Engineering Review

Drainage Letter 15905 Sniper Lane

Proposed Fountain Springs Addition No. 2
(Colorado Springs Police Department Firing Range)
El Paso County, Colorado

PPR-19-043

APPENDIX C
Drainage Plans
Sheet DR-1 – Proposed Drainage Plan

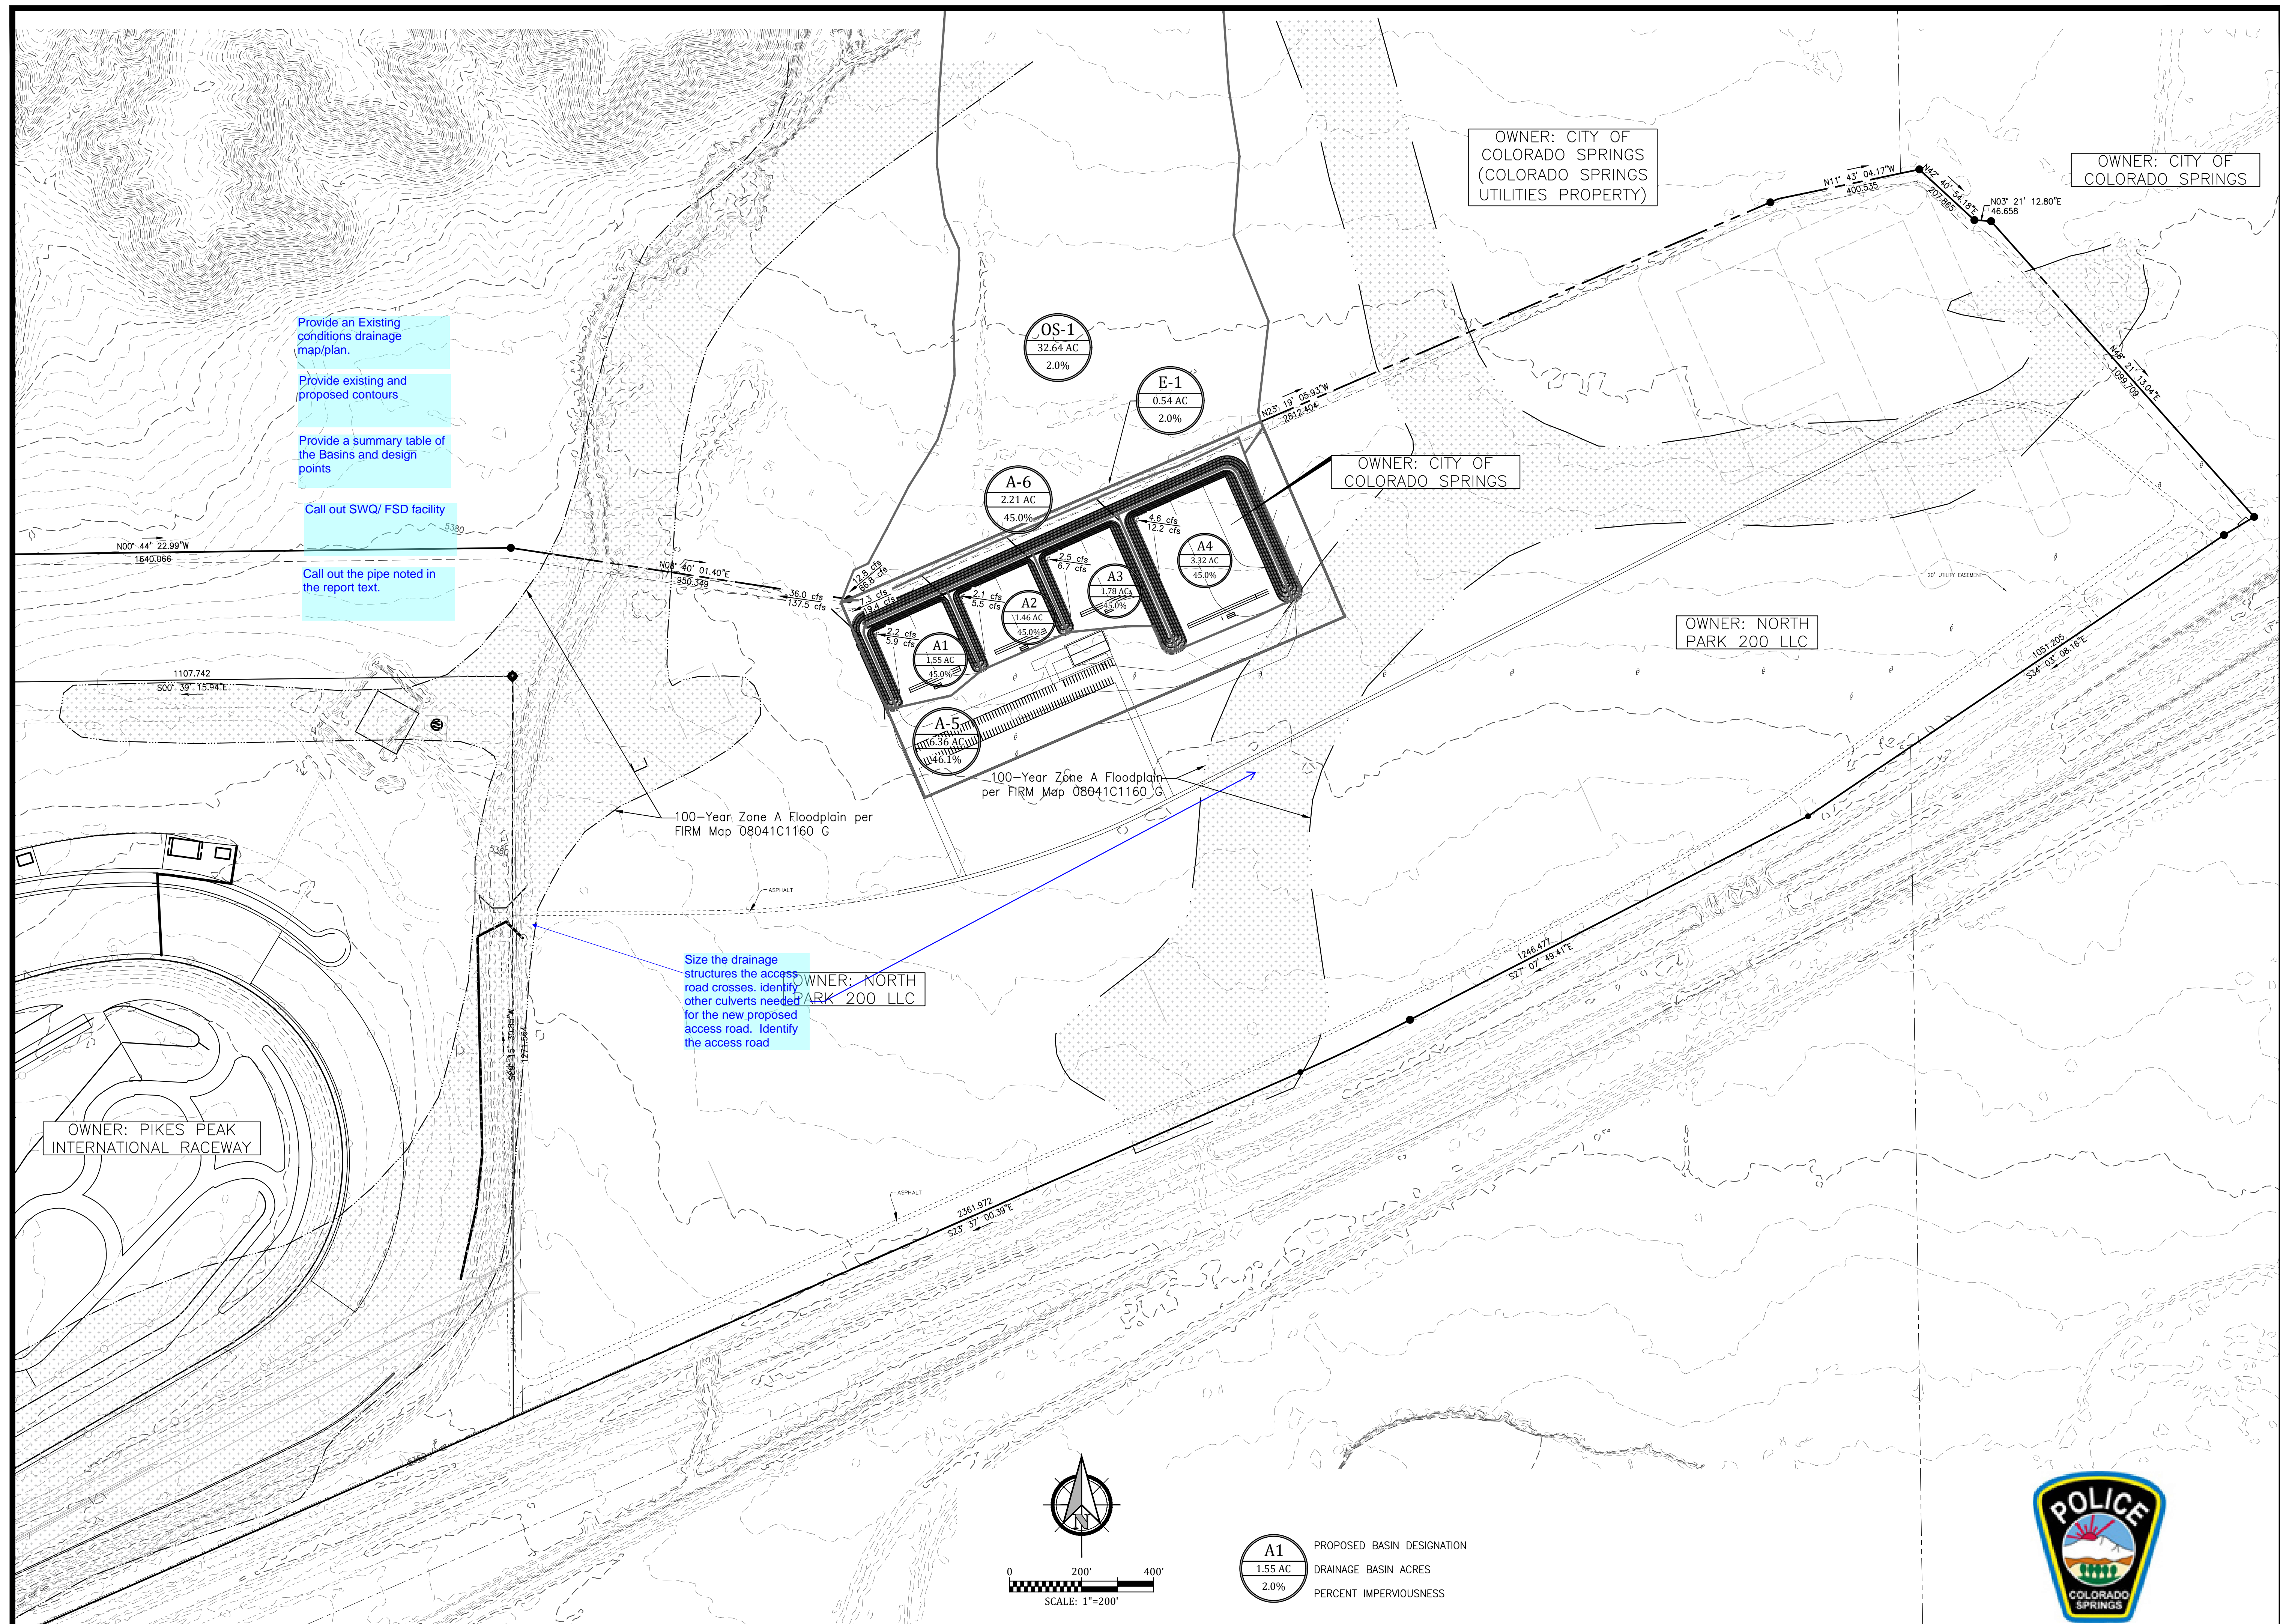
Provide existing and proposed contours

Provide an Existing conditions drainage map/plan.

Provide a summary table of the Basins and design points

Call out SWQ/ FSD facility

Call out the pipe noted in the report text.

Size the drainage structures the access road crosses. identify other culverts needed for the new proposed access road. Identify the access road
